**KNOXVILLE HISTORIC ZONING COMMISSION
STAFF REPORT - CERTIFICATE OF APPROPRIATENESS APPLICATION**

PROPERTY LOCATION: 629 Luttrell St. /
Parcel ID 94 D J 004

FILE NO.: 9-J-19-HZ

Seidler Residence Front Porch, 629 Luttrell Street, Knoxville TN

A5.7 Porch Details

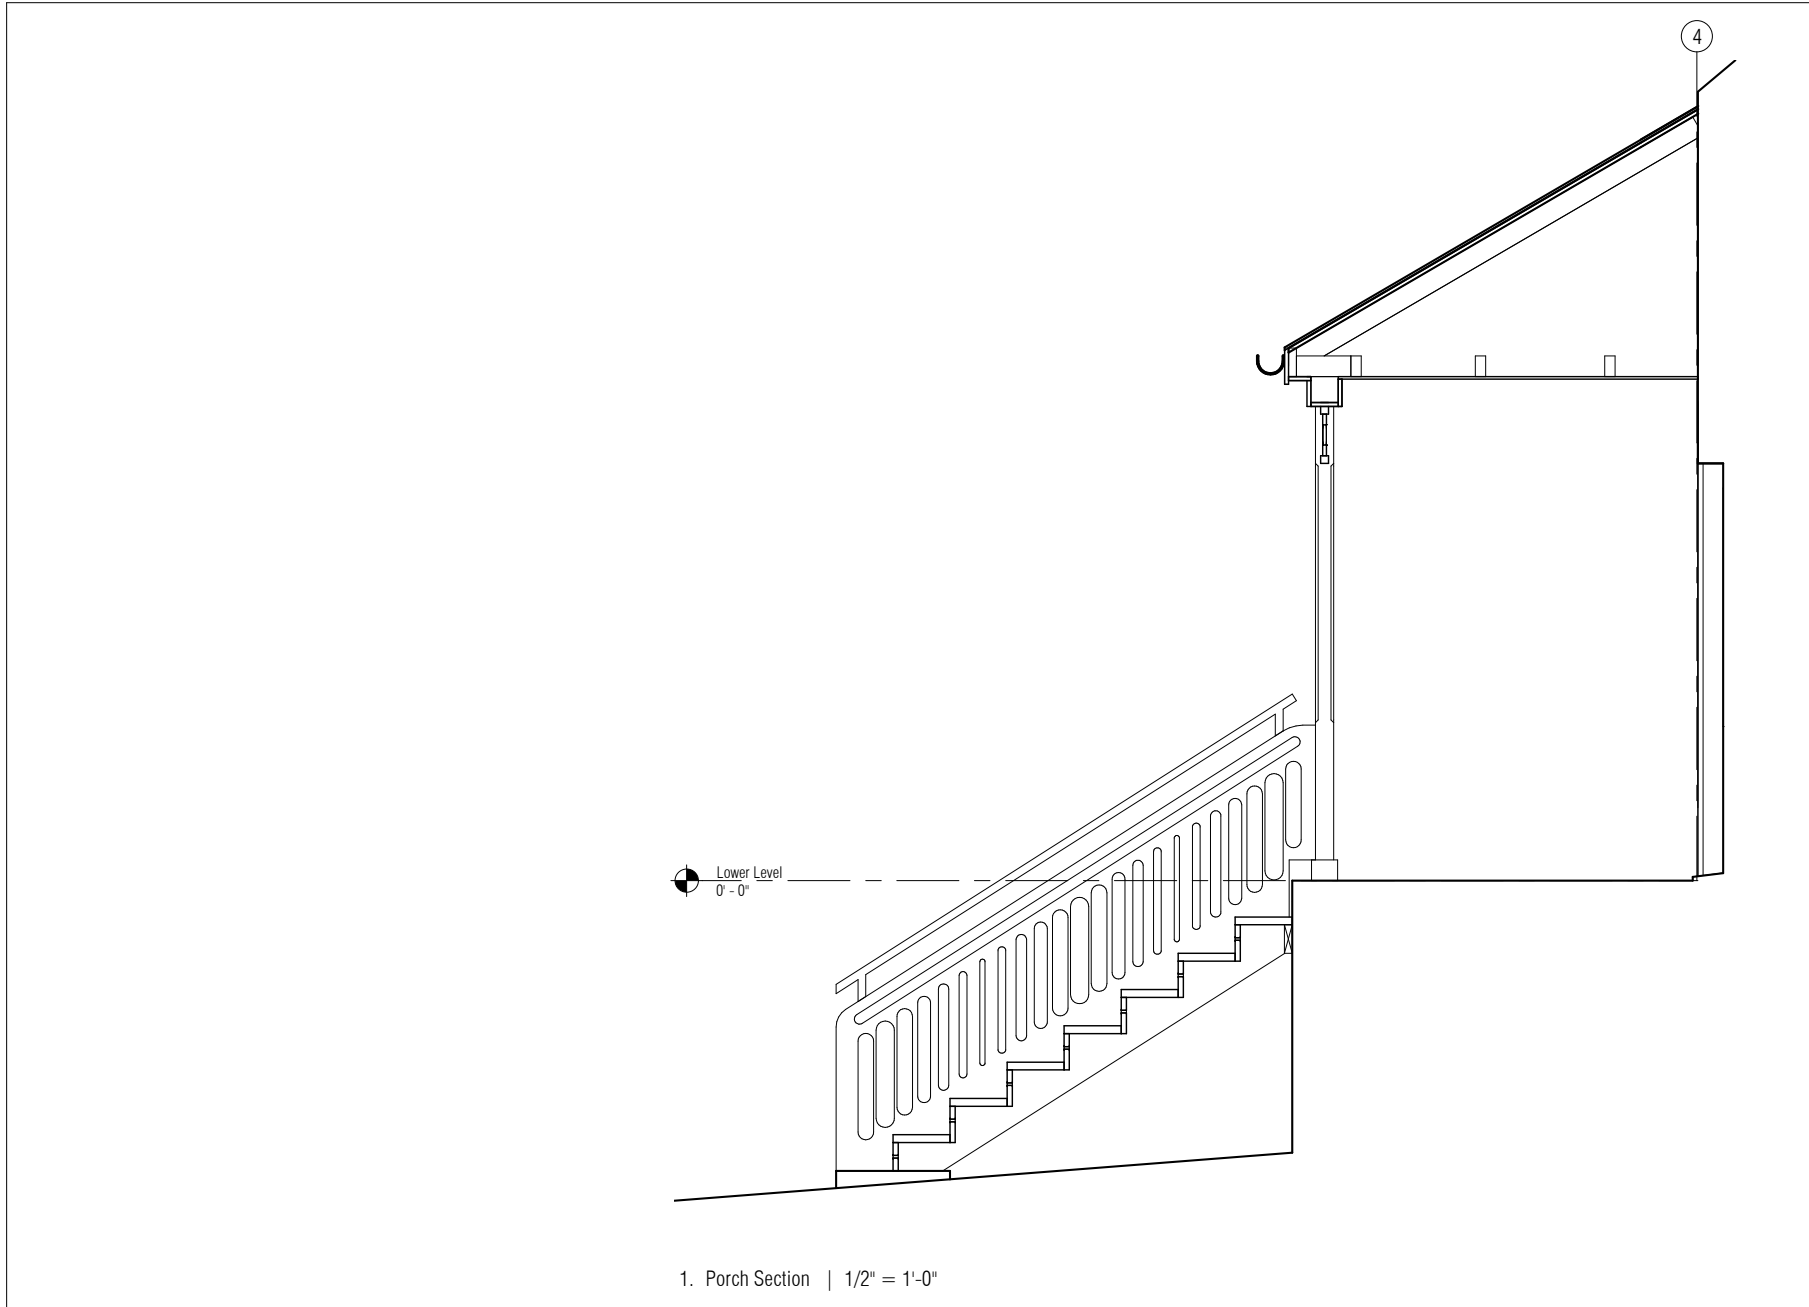
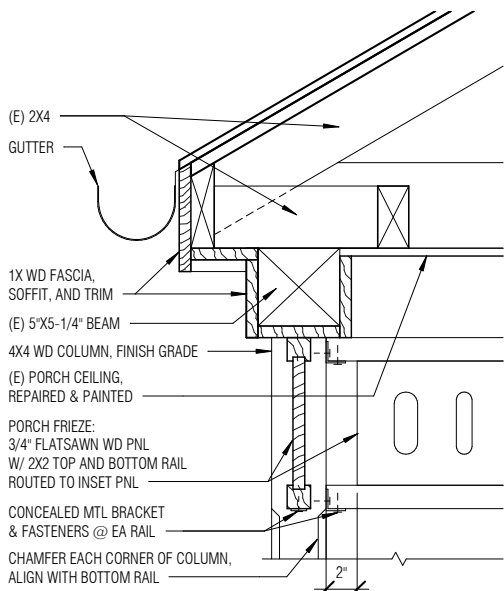
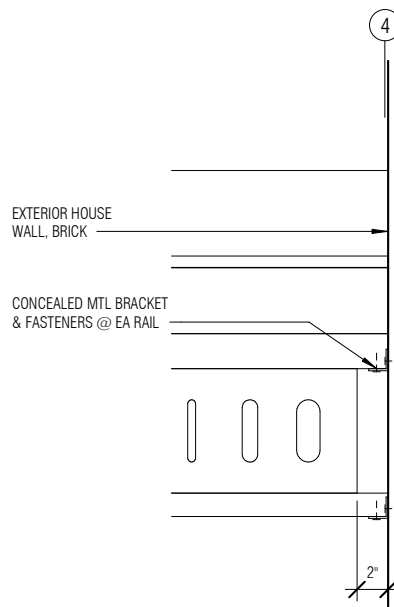
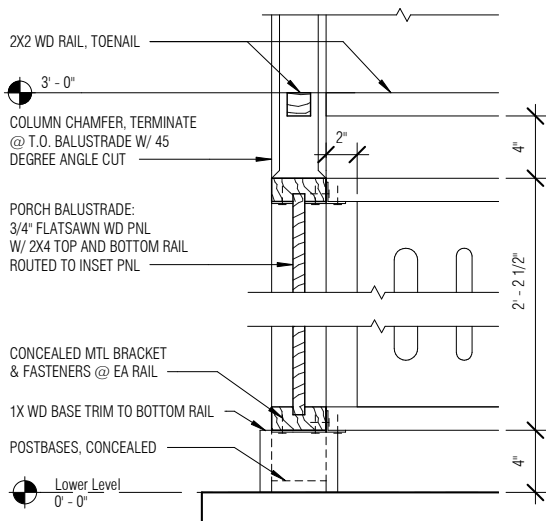
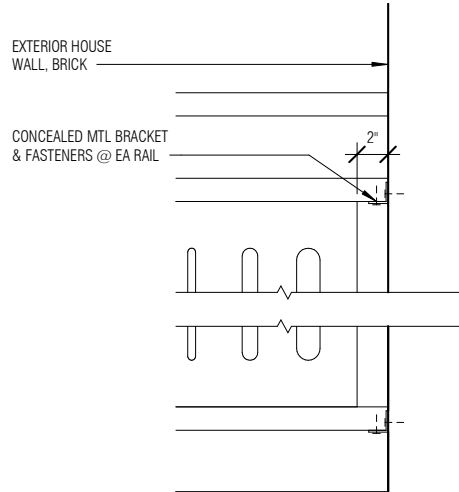
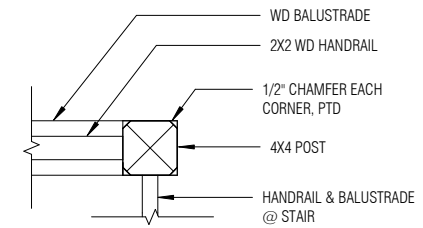
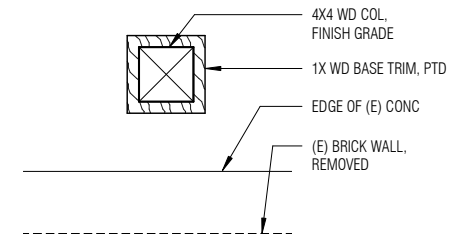
8. Per 2018 IRC (R311.7.8.4), handrails must end in a newel post or safety terminal.

Staff recommends approval of the work as proposed, with the following conditions: 1) the stair handrail be redesigned to include a newel post or safety terminal to meet codes, and 2) the applicant re-submit specifications for a door and sidelights more appropriate for the style of the house, for review and approval by staff.
